ADDENDUM #1

PROJECT: Secure Entry Office Addition and Building/Site updates
at Manor Elementary School
for Monroe Public Schools
#20161

TEMPERATURE
CONTROLS
SCHEMATICS

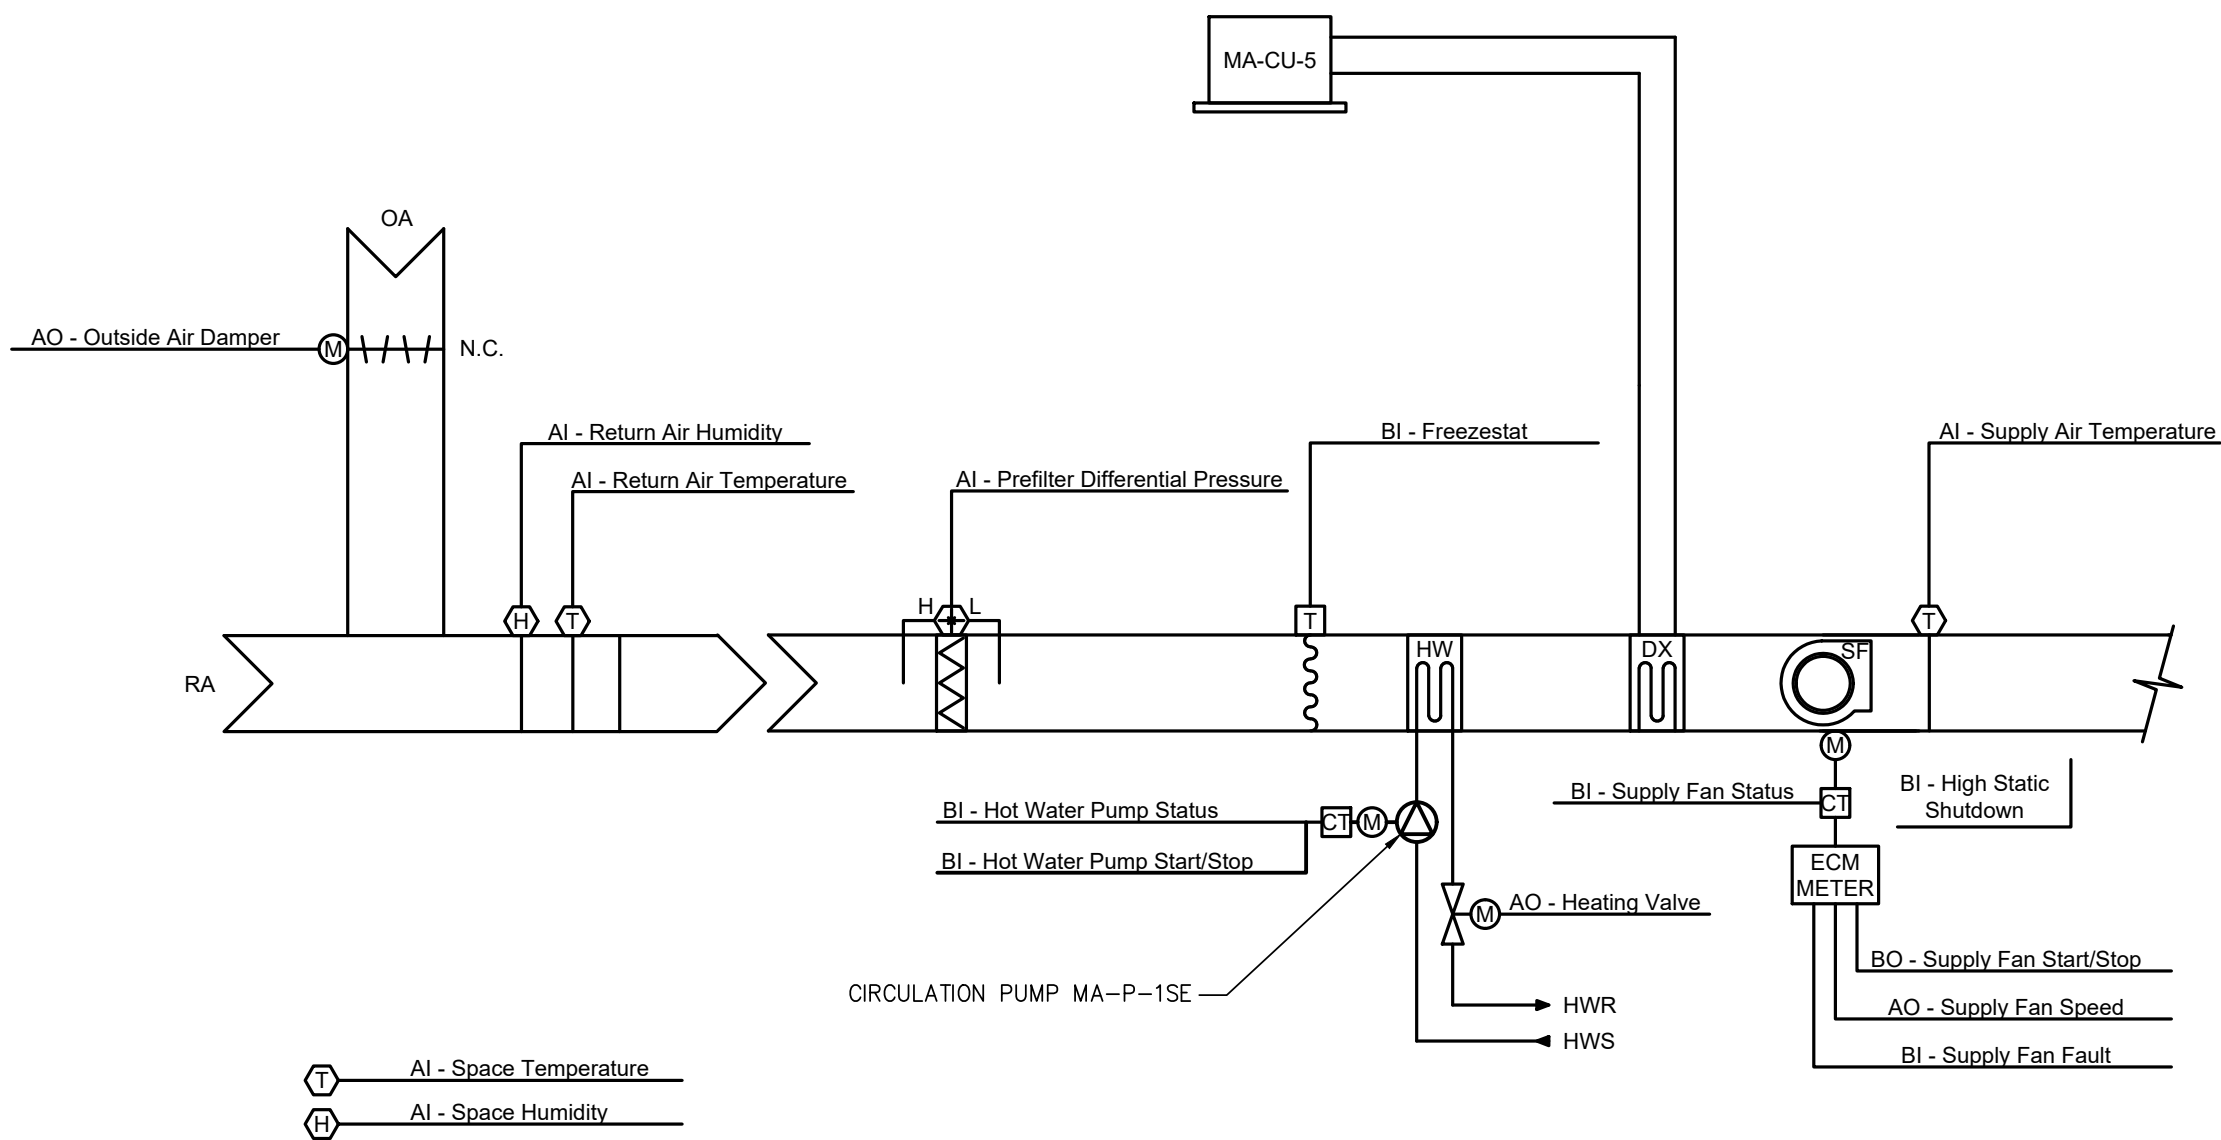
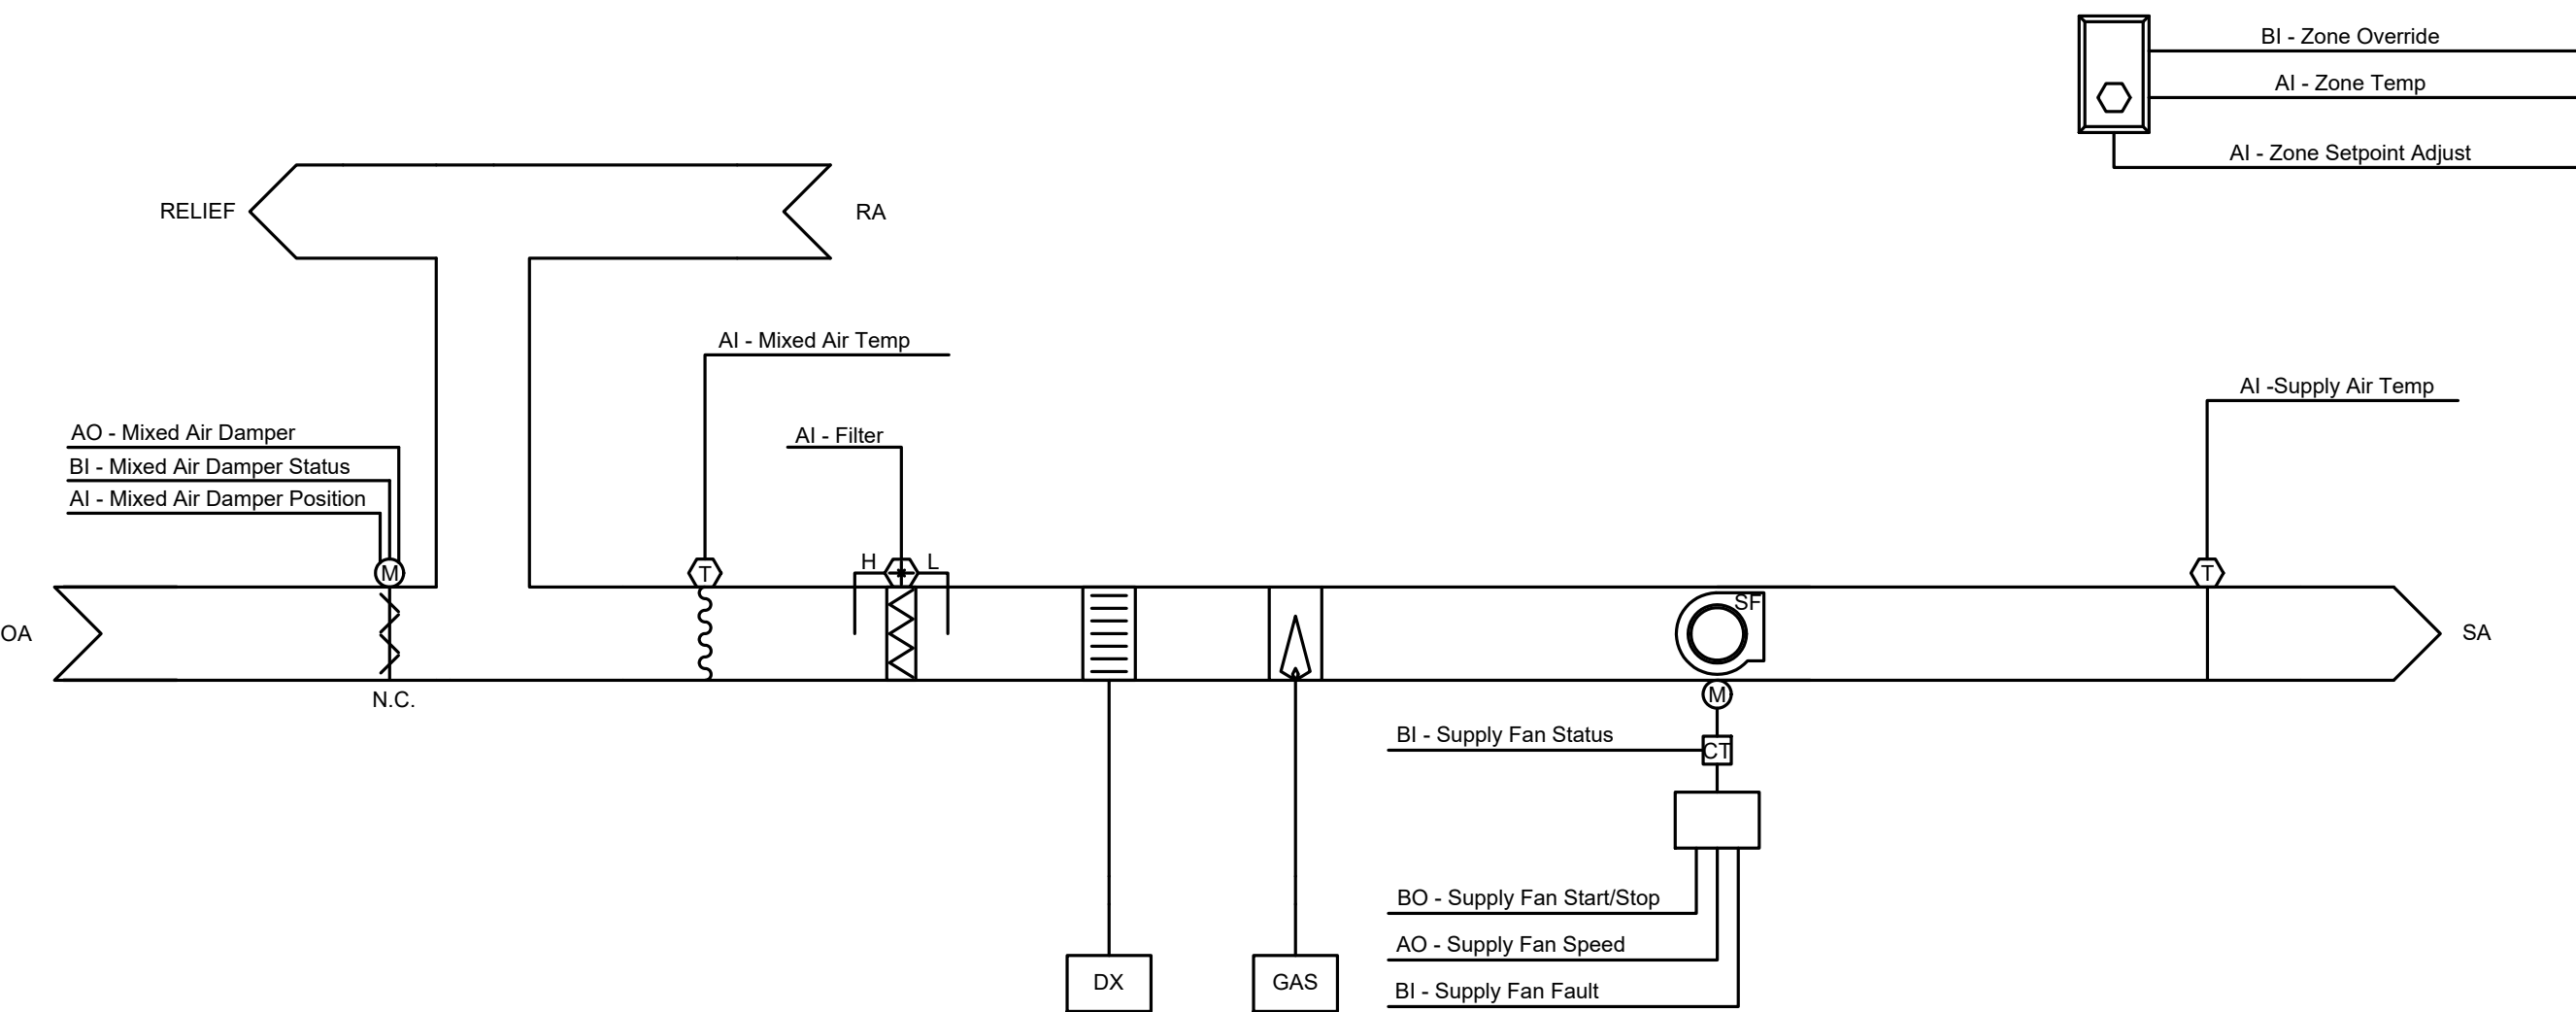
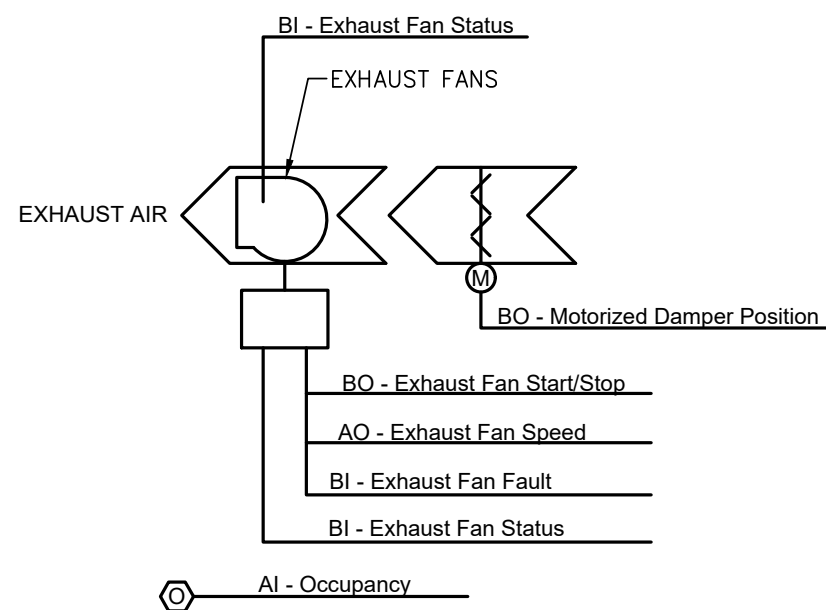
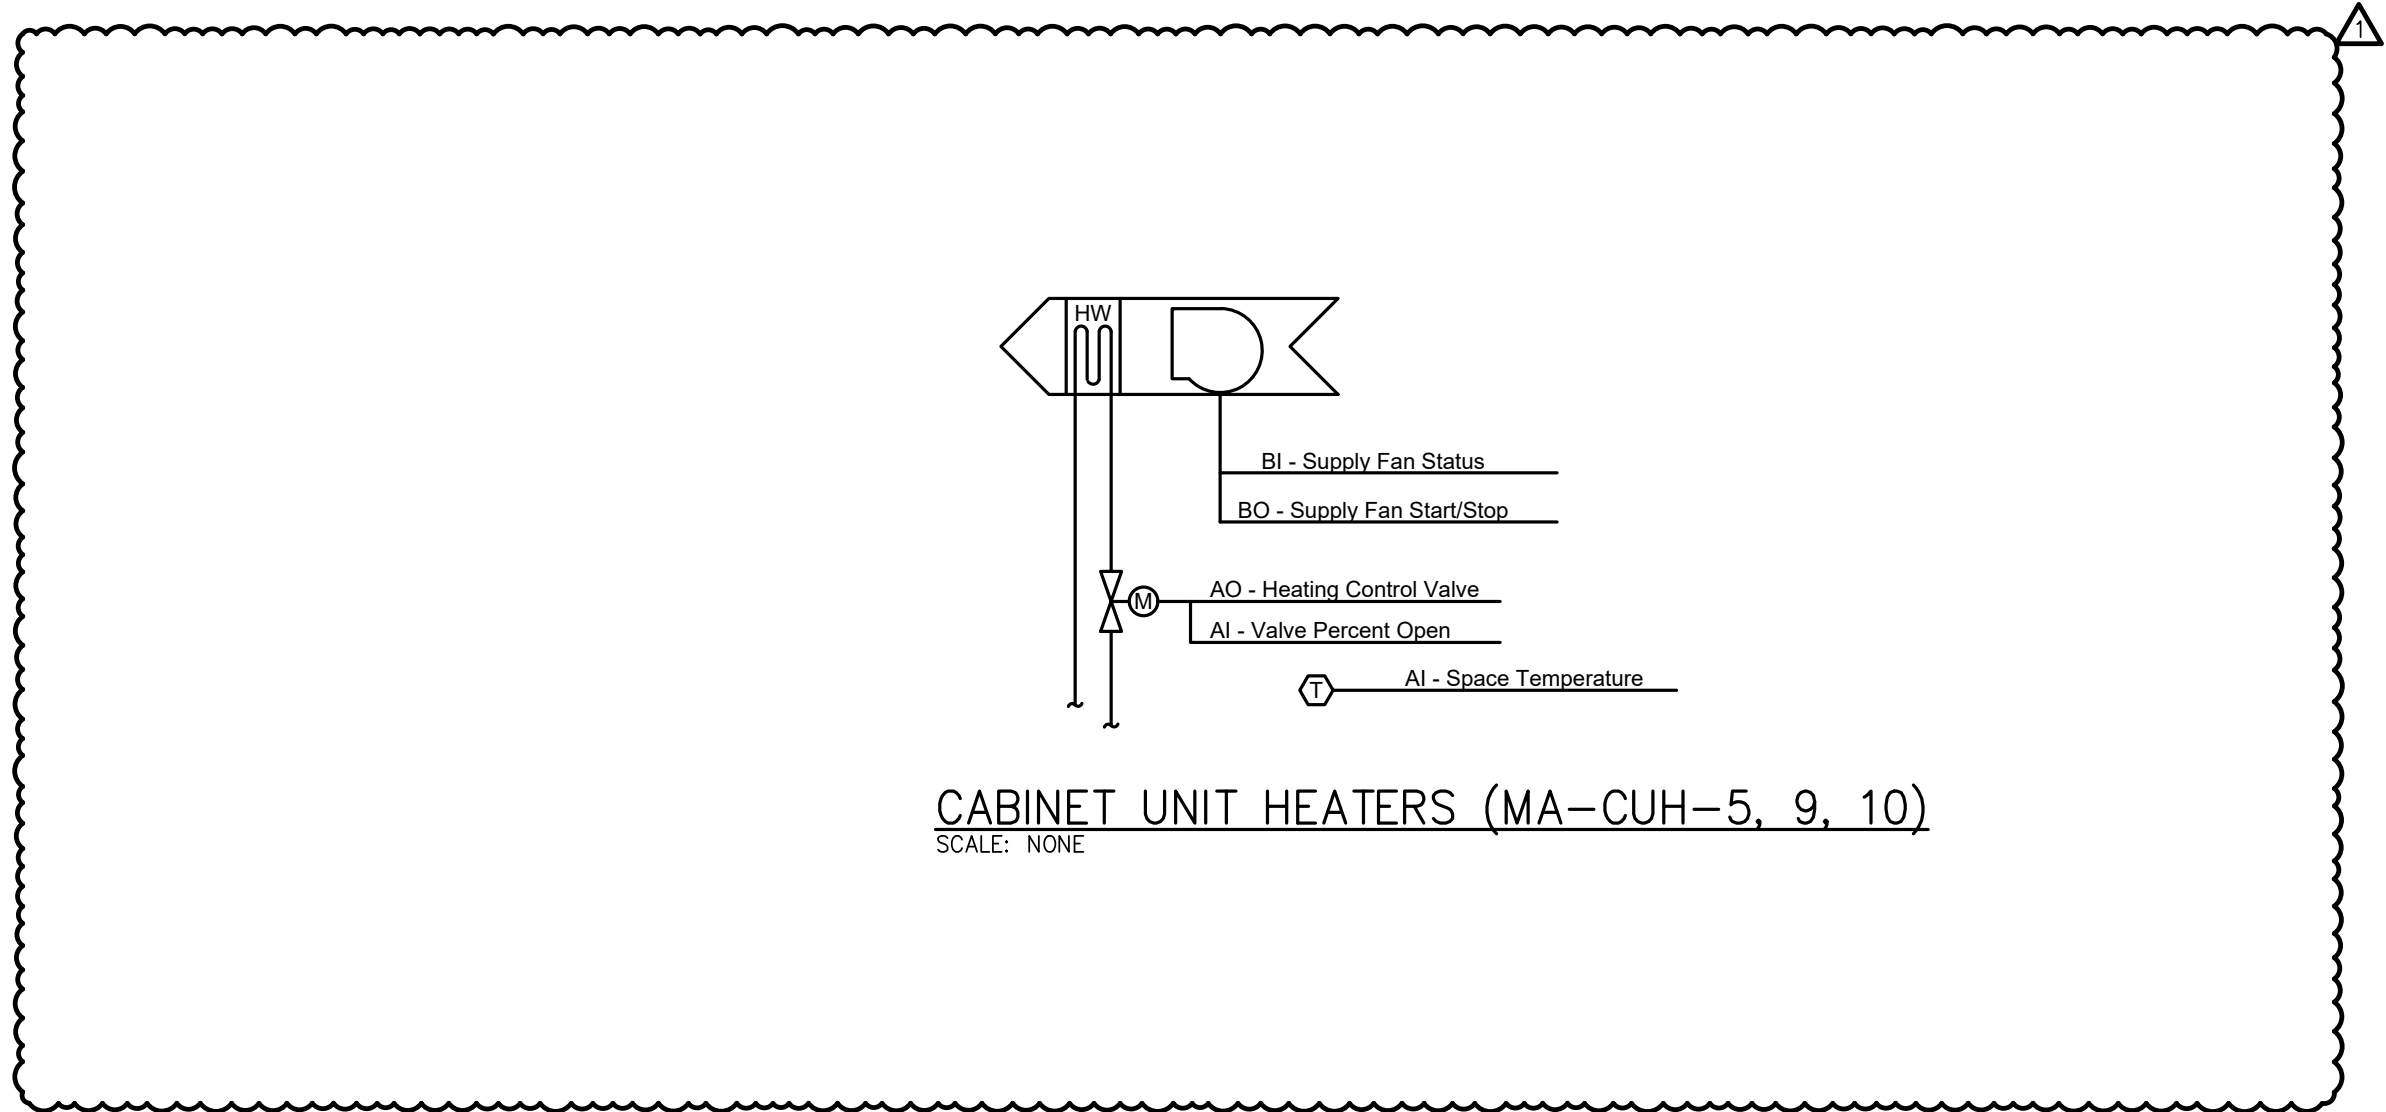
- F. Refer to drawing M6.02 TEMPERATURE CONTROLS SCHEMATICS (Re-issued Herein)
 - 1. Removed convector schematic.

ELECTRICAL
SINGLE-LINE
DIAGRAMS

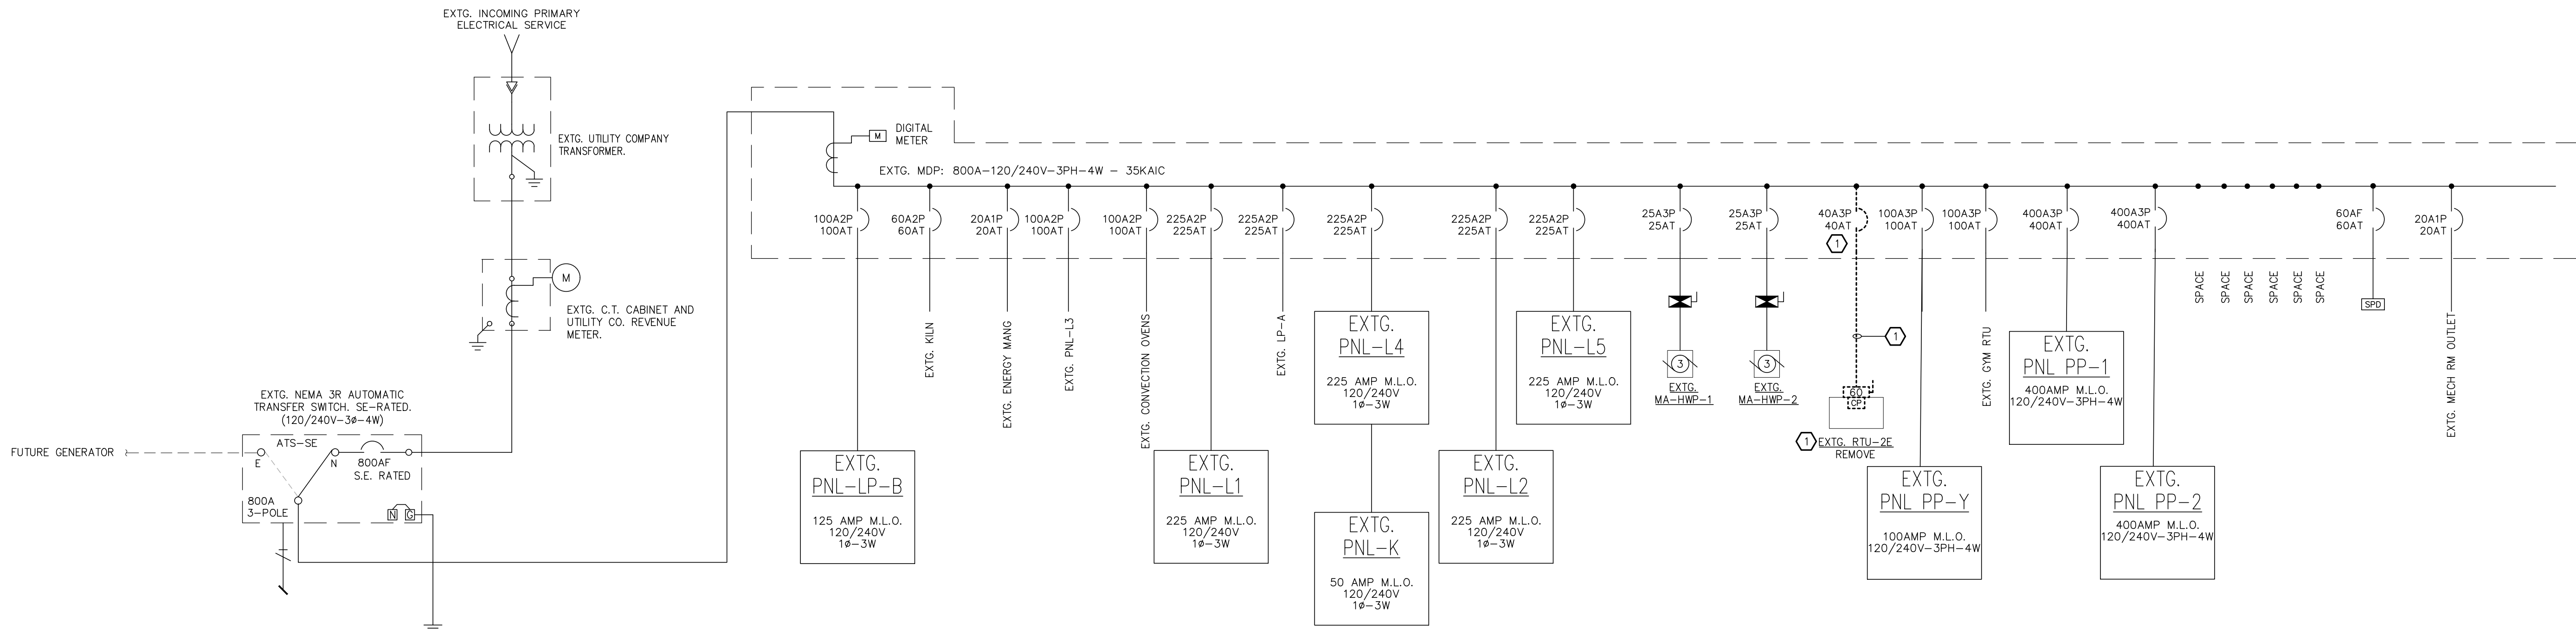
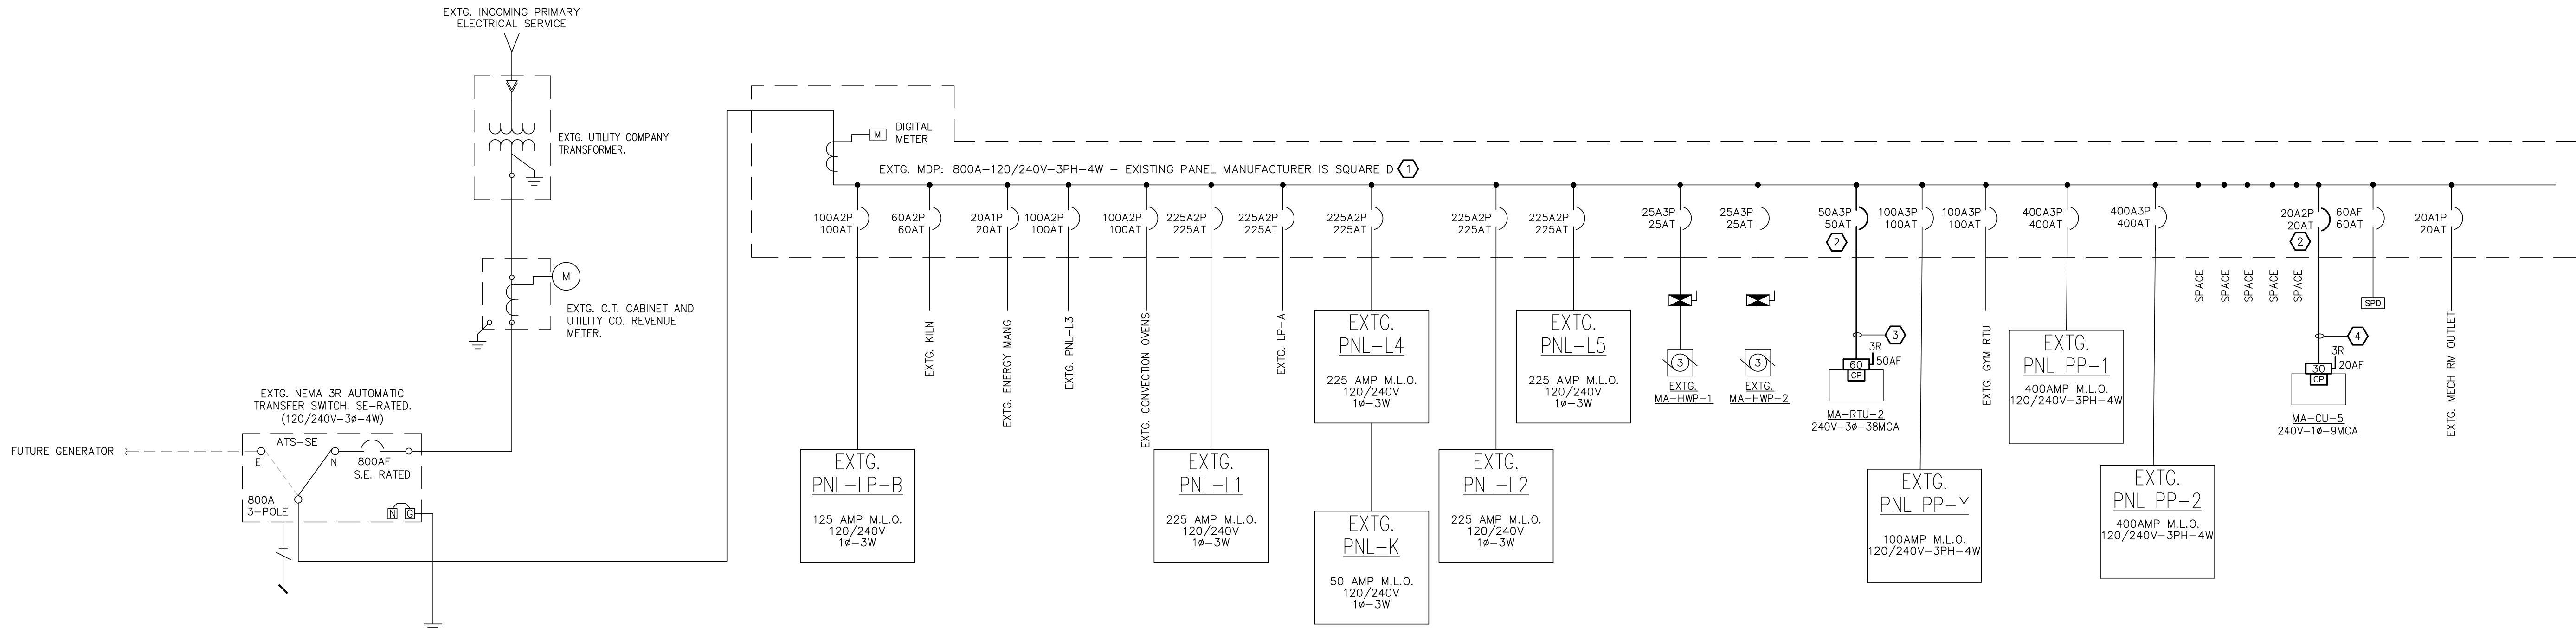
- A. Refer to drawing E1.03 ELECTRICAL SINGLE-LINE DIAGRAMS (Re-issued Herein)
 - 1. Revised load summary.
